# **Technical Service Information**

### FORD 4R100 INTERMEDIATE "DIODE" FREEWHEEL FAILURE

02-06 Page 1 of 3

Figure 1

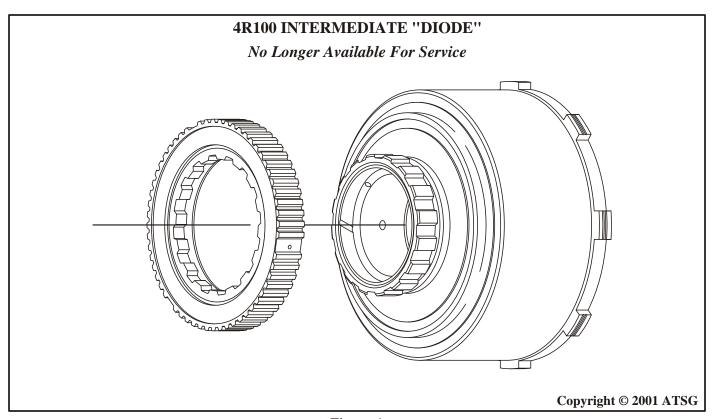
**COMPLAINT:** Some Ford Motor Company vehicles equipped with the 4R100 transmission may exhibit

premature failure of the newly introduced Intermediate "Diode" Freewheel device that was

installed in model year 2001 and illustrated in Figure 1.

**CAUSE:** The cause may be, more than expected load factors.

**CORRECTION:** The Intermediate "Diode" is *no longer serviced* by Ford Motor Company. The part number

Special Note: ATSG recommends replacing the Intermediate "Diode" during service, even if it has not yet failed, to protect yourself from possible future failures.
